MARK	DATE	DESCRIPTIONS	BY	CH'D	CCO#
△1	03/04/08	BARRIER MODIFICATIONS	JS BM	RG SE	44

DETAILS
SAS SUPERSTRUCTURE ROADWAY WESTBOUND PANEL UP-108 SCHEDULE
NO SCALE

E-63

CU 04251 EA 0120F1

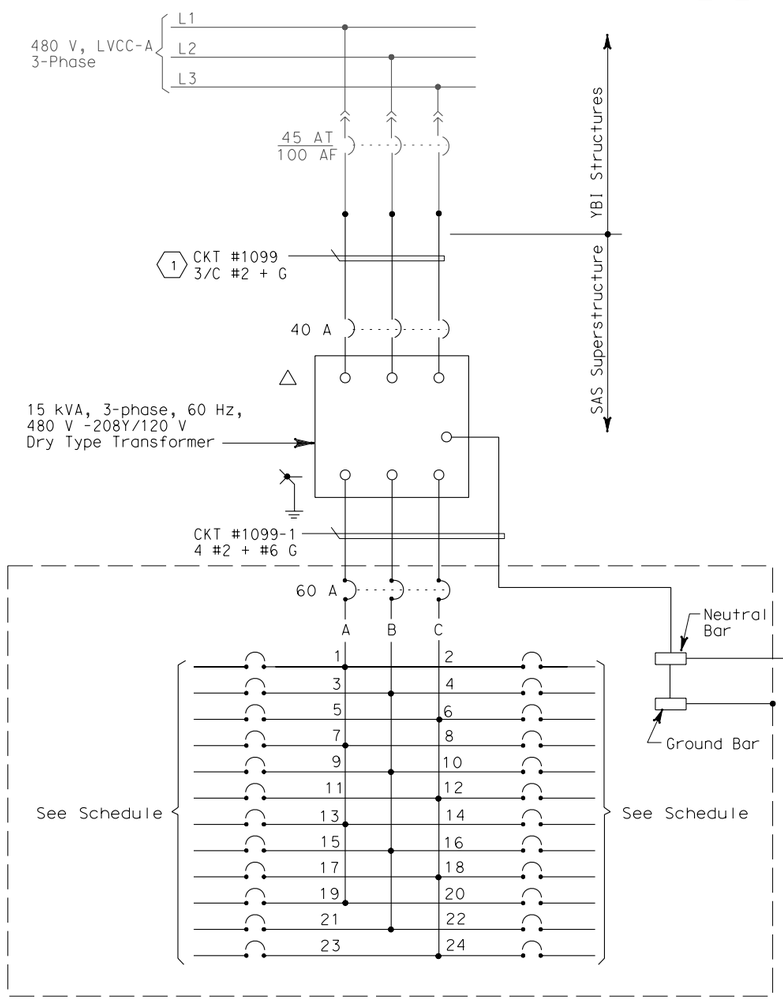
LOAD DESCRIPTION	LTG	REC	OTH.	CB		CB	LTG	REC	OTH.	LOAD DESCRIPTION
Recept (1) Westbound North Barrier		180		20/1	1 A 2	20/1			10	CB-143A
Recept (3) Westbound South Barrier		540		20/1	3 B 4	20/1			10 △1	CB-143B 1
Recept (2) Service Platform #8		360		20/1	5 C 6	20/1				Spare
Recept (3) Girder		540		20/1	7 A 8	20/1	984			Girder Ltg. (24)
Recept (6) Crossbeams		1080		20/1	9 B 10	20/1	738			Crossbeam Ltg (20)
RTU #11W (Lighting & Receptacle)	105	180	150	20/1	11 C 12	20/1	820			Crossbeam Ltg (20)
Recept (1) Crossbeams		180		20/1	13 A 14	20/1				Spare
Spare				20/1	15 B 16	20/1				Spare
RTU #11W (PLC Power Supply)			100	20/1	17 C 18	20/1				
Spare				20/1	19 A 20	20/1				
				20/1	21 B 22	20/1				
				20/1	23 C 24	20/1				
TOTAL VA	105	3060	250				2542	△1	20	TOTAL VA

TOTAL kVA: 5.977 △1

Phase A - 1.884 △1
Phase B - 2.358
Phase C - 1.715
